Subject: Issuance of Amendment No. 34 to Facility Operating License NPF-35
and Amendment No. 25 to Facility Operating License NPF-52 - Catawba
Nuclear Station, Units 1 and 2 (TACs 59641/60928)

ATTACHMENT TO LICENSE AMENDMENT NO. 34

SAFETY EVALUATION BY THE OFFICE OF NUCLEAR REACTOR REGULATION
RELATED TO AMENDMENT NO. 34 TO FACILITY OPERATING LICENSE NPF-35
AND AMENDMENT NO. 25 TO FACILITY OPERATING LICENSE NPF-52
CATAWBA NUCLEAR STATION, UNITS 1 AND 2
DUKE POWER COMPANY, ET AL.

FIGURE 3.2-3
REACTOR COOLANT SYSTEM TOTAL FLOW RATE VERSUS R - FOUR LOOPS IN OPERATION

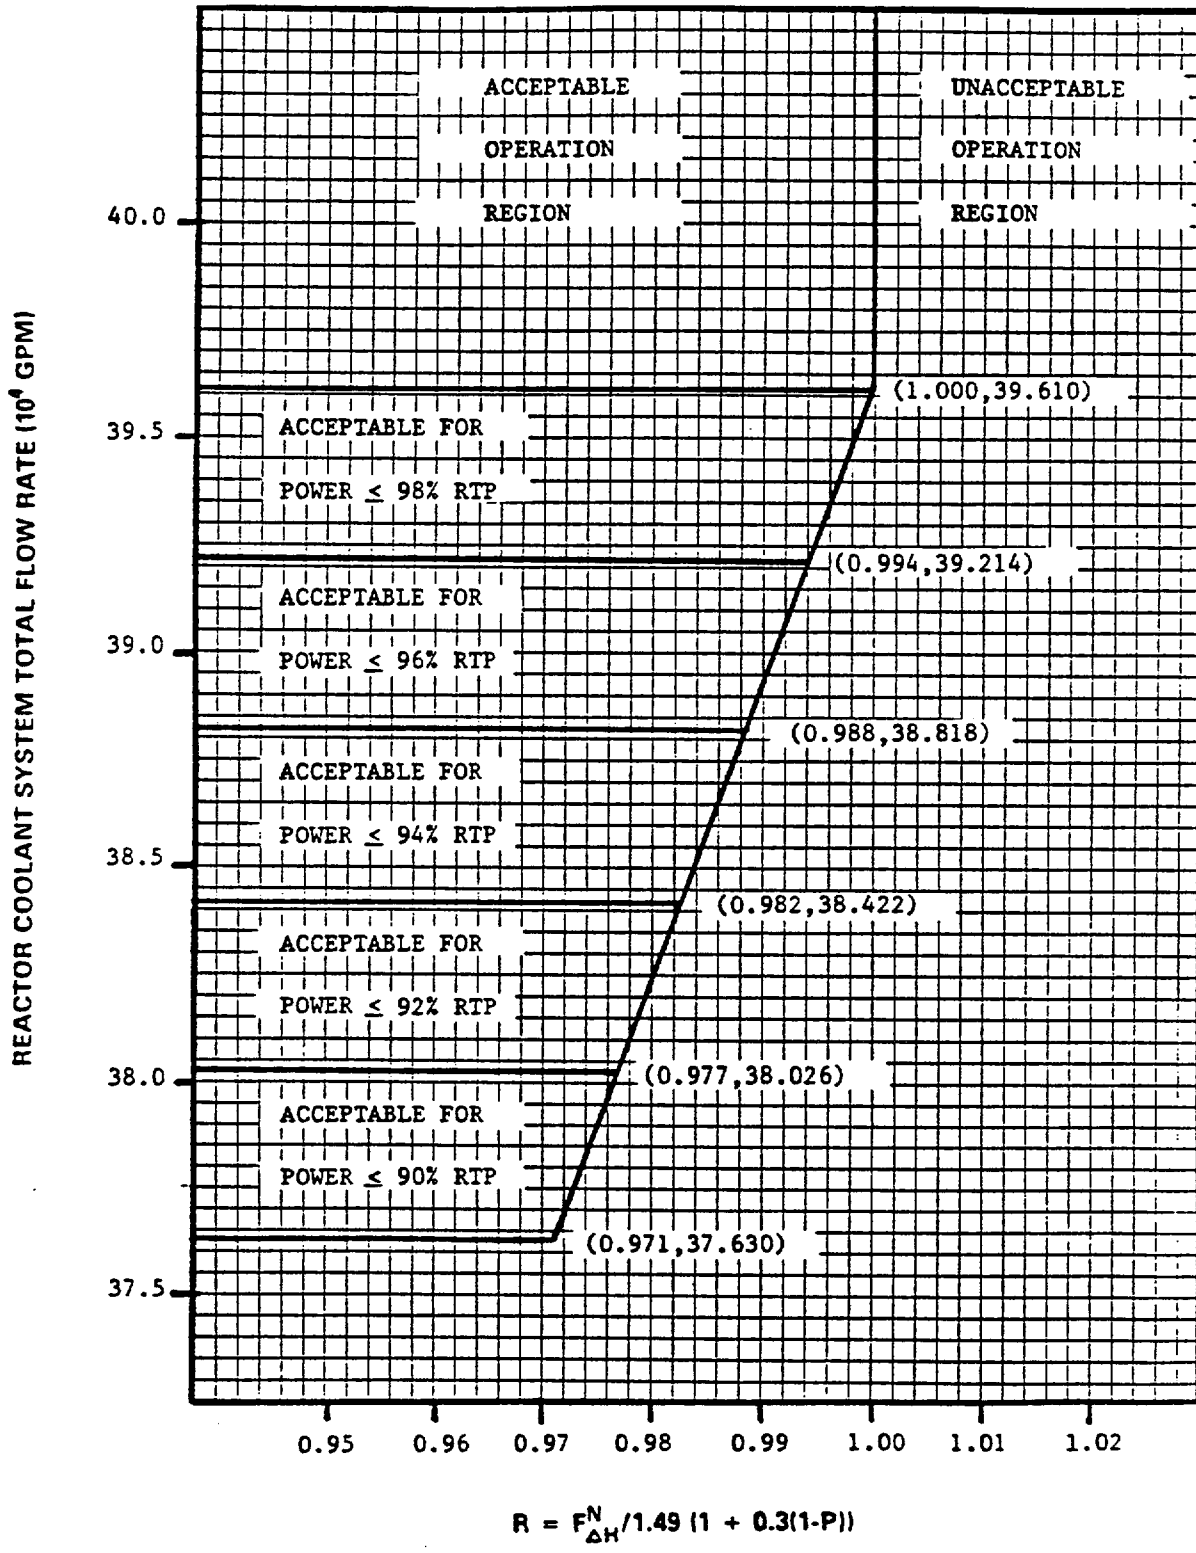
The amendments would add an action statement to Technical Specification 3/4.2.3, and would modify Figure 3.2-3 to delete the DNB limit line and add a graduated scale to allow a tradeoff of reactor coolant system flow against reactor thermal power level. The amendments are effective as of the date of issuance.

By letter dated July 31, 1985, and supplemented November 8 and December 26, 1985, and March 7, 1986, Duke Power Company, et al., (the licensee) proposed changes to Figure 3.2-3 of Technical Specification (TS) 3/4.2.3 for Catawba Nuclear Station, Units 1 and 2. The changes would delete the DNB limit line and add a graduated scale to allow tradeoff of reactor coolant system (RCS) flow against reactor thermal power (RTP) level.

The licensee proposes that Figure 3.2-3 titled "Reactor Coolant System Total Flow Rate Versus R-Four Loops in Operation" be modified to permit operation at a reduced flow rate (i.e., about 95% of full flow) which would be compensated by an appropriate reduction in reactor power level. The reduced power level ensures that the thermal margin is maintained at a value equivalent to that for full flow. In addition, the licensee proposes to delete the DNB limit line to prevent operation misinterpretation because the rod bow factor (R_2) is not associated with TS 3/4.2.3 or Figure 3.2-3 and thus the DNB limit line serves no useful purpose.

The licensee proposes to reduce RTP level by 2% for each 1% reduction in the measured RCS flow below the TS flow requirement for 100% power which is equal to 396,100 gpm. Westinghouse calculations show, with penalties added for conservatism, that a 5% reduction in flow results in a 4.4% reduction in power. The staff's independent audit (using W-3 correlation sensitivity factors reported in References (1) and (2)) show that, for the worst case reported in Reference (2), a 5% reduction in flow requires a 4.32% reduction in power. The licensee's plan to use a 10% reduction in power for a 5% reduction in flow is conservative. Furthermore, this ratio of RTP level to RCS flow was used for the McGuire Nuclear Station TS and has been reviewed and approved by the NRC staff.

The staff also finds the elimination of the DNB limit line in Figure 3.2-3 to be acceptable as it was originally for an "R₂" value associated with rod bow penalty. In the November 8, 1985, letter, the licensee stated that a rod bow penalty is not applied to Catawba as there is approximately 10% margin between the safety analysis and design limit DNBR values. This is partially used to offset a 2.7% DNBR rod bow penalty. The staff agrees with the licensee's statements and licensee's treatment of rod bow penalty.

The licensee has factored the 2/1 power to flow tradeoff into the F Delta-H equation and in Figure 3.2-3. For example, at the maximum power reduction of 10% corresponding to a flow reduction of 5% and with F Delta-H maintained at the full power value of 1.49, the value of R is 0.971. This condition is shown in Figure 3.2-3 where RTP equals 90% and the RCS flow is 95% of the required flow or $.95 \times (396,100 \text{ gpm}) = 376,3000 \text{ gpm}$.

The limitation placed on F Delta-H for reduced RCS flow conditions prevents the usual allowance for increasing F Delta-H at reduced power levels. Reductions in power levels combined with a RCS flow deficiency and increased radial peaking do not maintain DNBR margin and thus the F Delta-H restrictions in Figure 3.2-3 are required.

Based on the above evaluation, the staff concludes that the proposed modification to Figure 3.2-3 of TS 3/4.2.3 for using a 2/1 power to flow relationship for a maximum of 5% reduction in flow is acceptable.

Based on its review, the staff finds that Figure 3.2-3 was appropriately adjusted and, therefore, it is acceptable.
